Addendum to GR's Report No. 34638.003, Work Plan For Monitoring Well Installation (dated August 25, 1998), Chevron Station #9-4800, 1700 Castro Street, Oakland, CA.

Chevron Service Station No. 9-4800 1700 Castro Street Oakland, California DATE

Figure 2. Site Plan

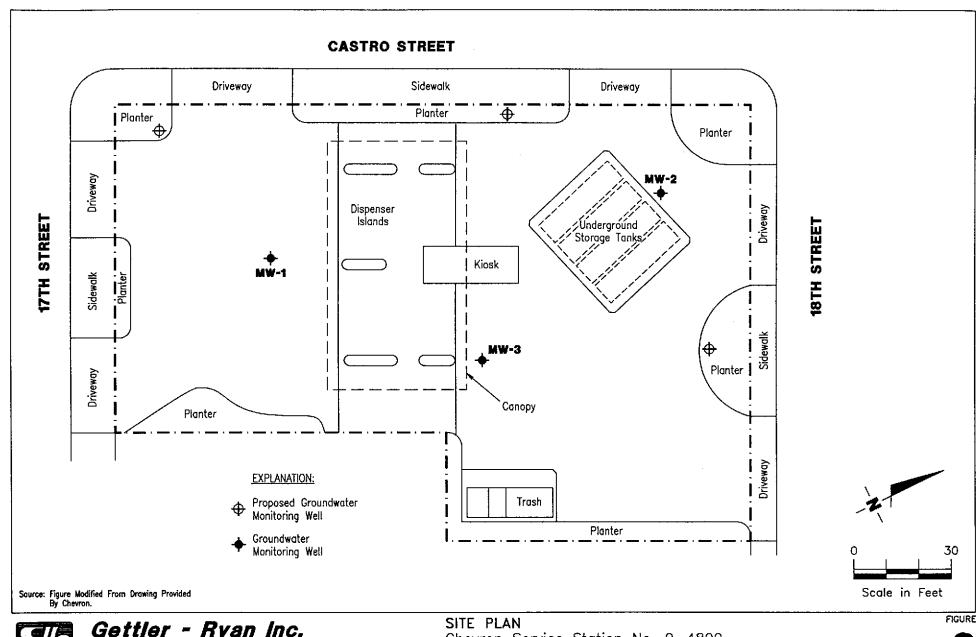
This Work Plan Addendum was prepared at the request of Chevron Products Company. The original Work Plan proposed installation of one upgradient well adjacent to 18th Street, and one downgradient well adjacent to Castro Street. At the request of Ms. Eva Chu, Alameda County Health Care Services Agency, Chevron will install one additional downgradient groundwater monitoring well in the southwest corner of the site at the intersection of 17th and Castro Streets. Sample handling and well construction procedures are discussed in the original Work Plan. The proposed location of this well is shown on Figure 2 (attached).
